MAY 16, 2018
BOARD OF COUNTY COMMISSIONERS
ORANGE COUNTY FLORIDA
ADDENDUM NO. 2/IFB NO. Y18-759
ORANGE COUNTY PORTER TRANSFER STATION SITE IMPROVEMENTS

THE REVISED BID OPENING DATE IS MAY 22, 2018

SHEET TITLE
HHW SECTIONS AND DETAILS
 PROJECT TITLE
**PORTER TRANSFER STATION
 SITE IMPROVEMENTS**

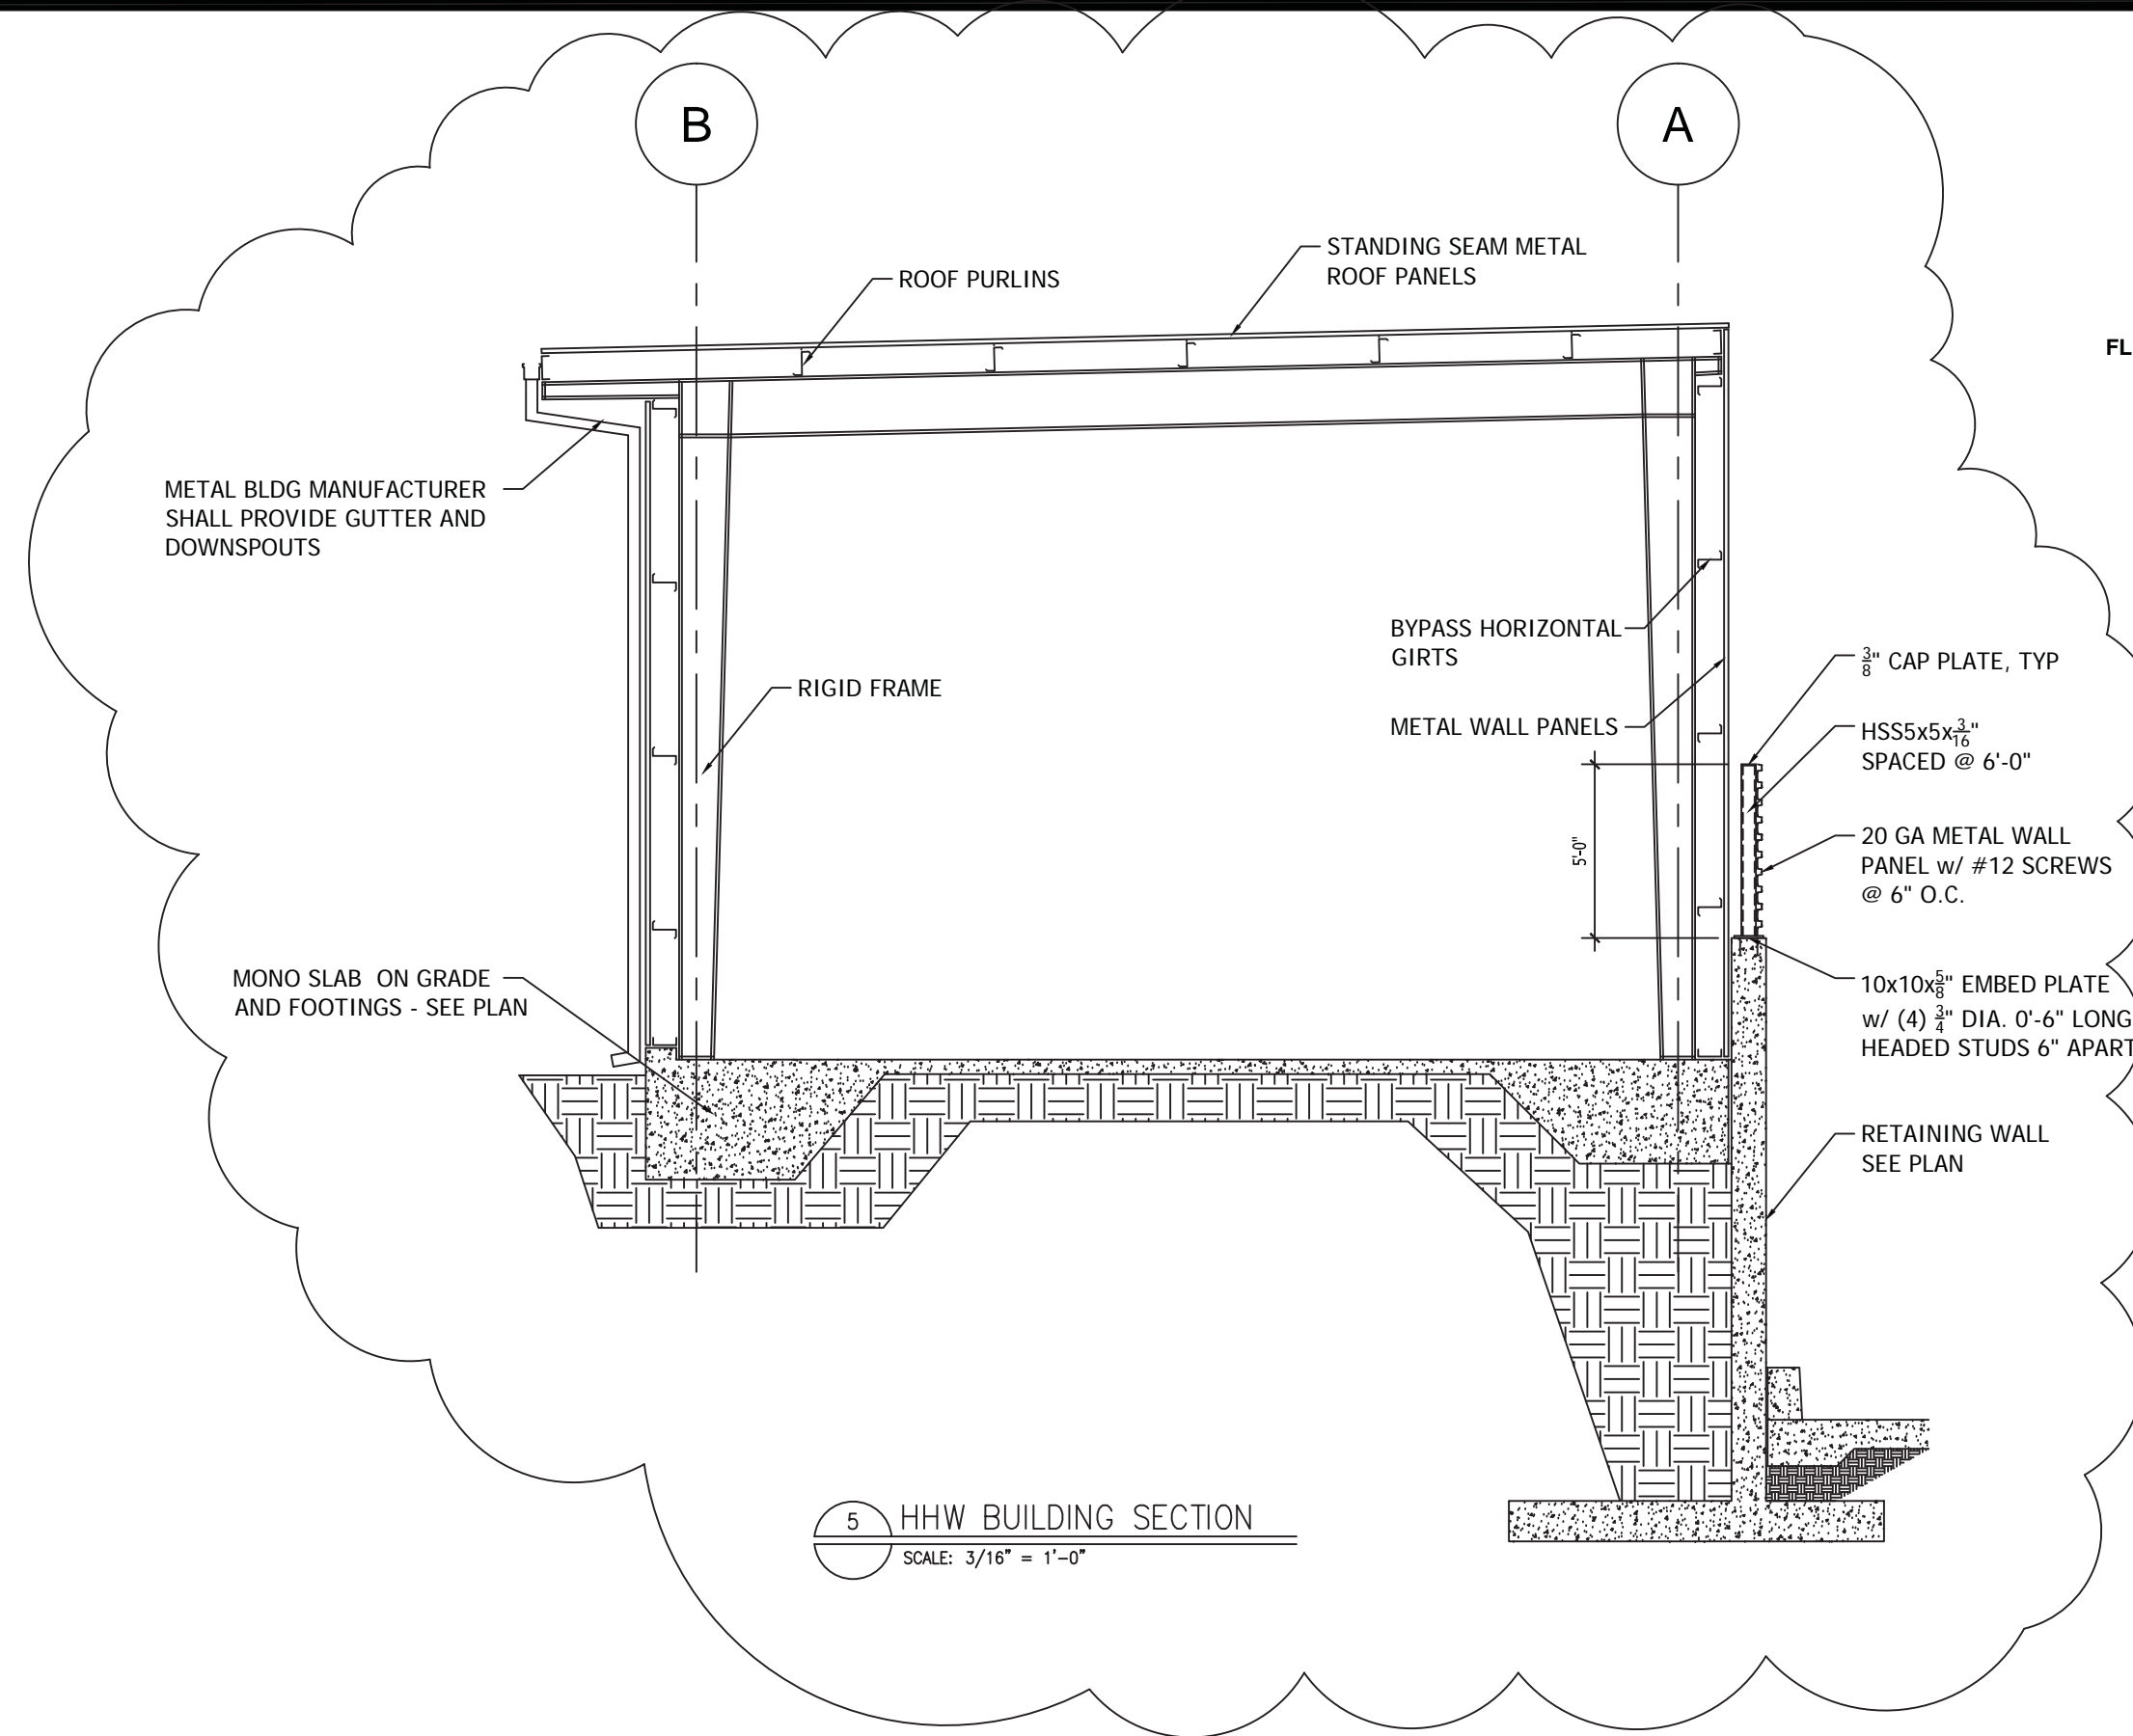
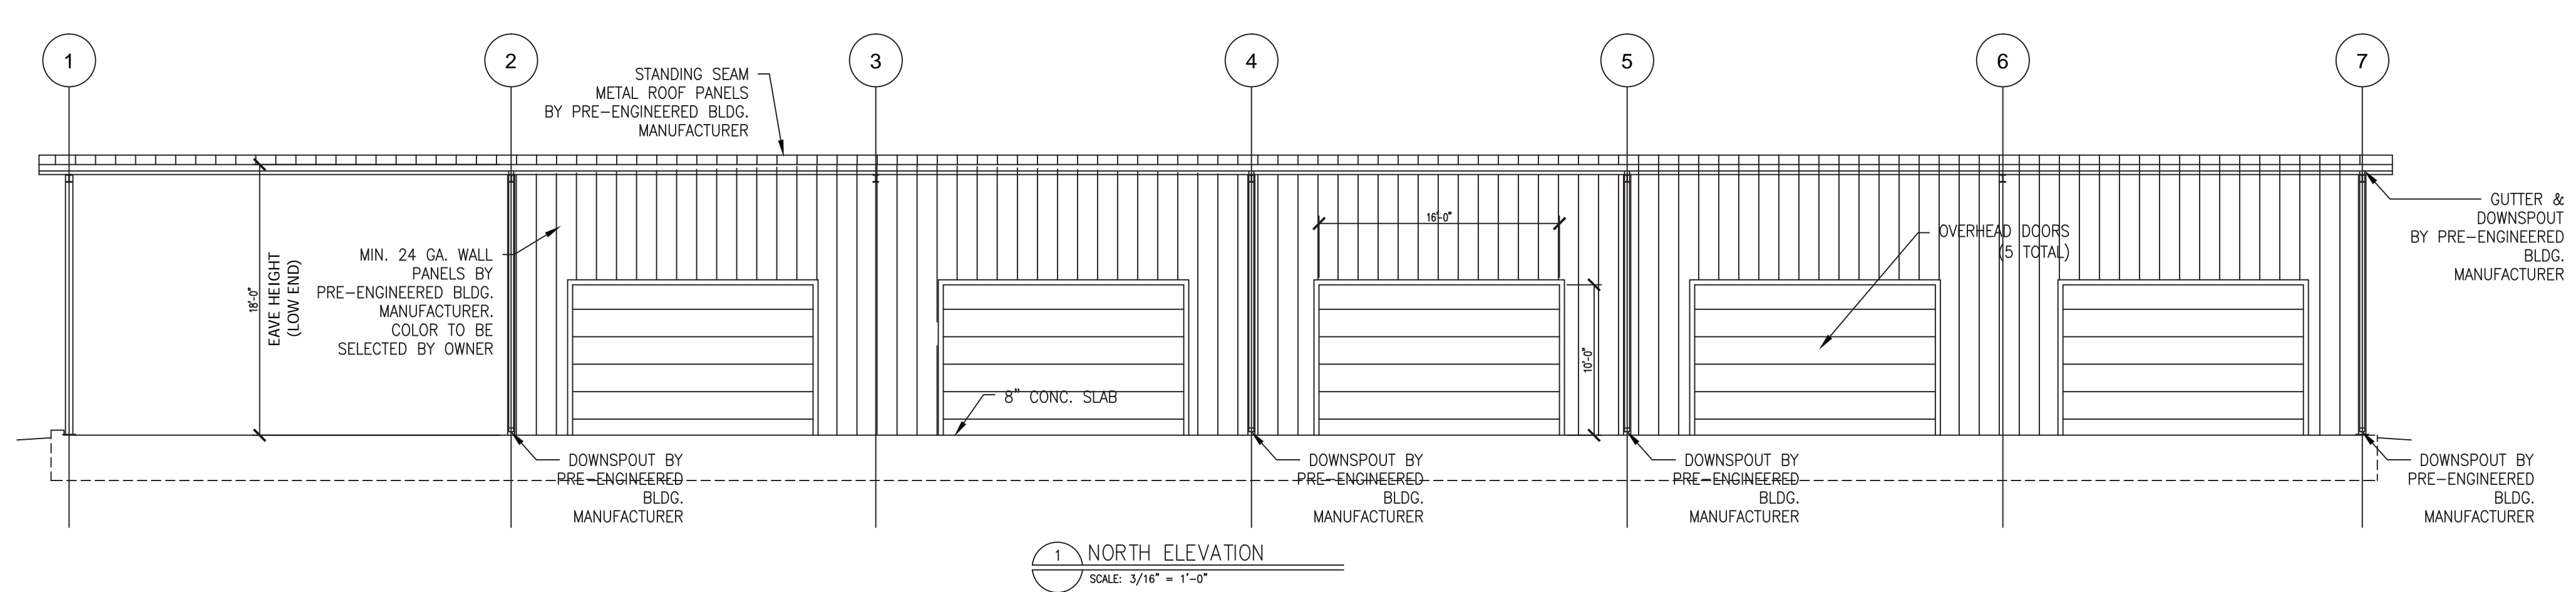
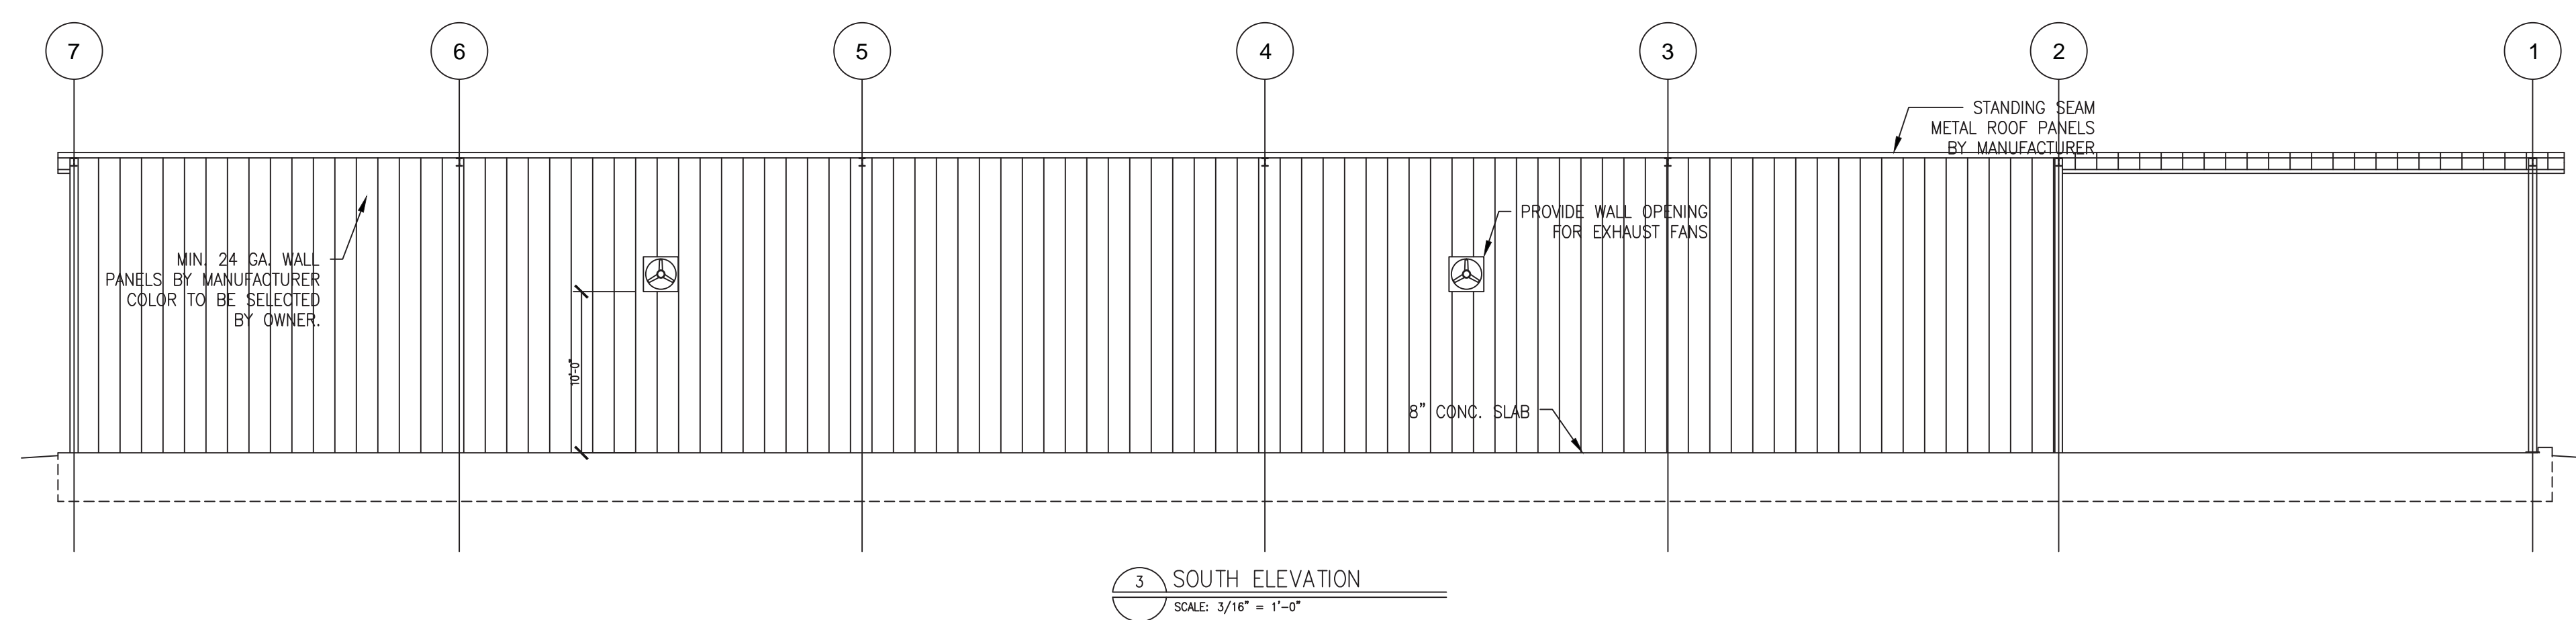
7. **Question:** Detail 5/S10 shows a retaining wall abutting the P.E.M.B. wall panels along the high sidewall of the building. Can the wall panels along the High sidewall be terminated at the top of the retaining wall elevation, 4'-0" AFF?

- Response:** No. The horizontal girts shown on Detail 5 of Sheet S-10 may be re-spaced or adjusted for ease of wall panel construction.
8. **Question:** Please confirm 3'-0" roof overhang at high sidewall extending into Truck Transfer Trailer Bay.

- Response:** Refer to the updated Drawing S10. The roof overhang shall not extend into the trailer bay. The roof shall extend 3'-0" from the south side of the building. There shall be no overhang over the Transfer Trailer Bay side.

CHK. BY	DESCRIPTION	DATE	REV
	REVISED IN RESPONSE TO BID ADDENDA 2	5/14/18	1
			2
			3
			4
			5
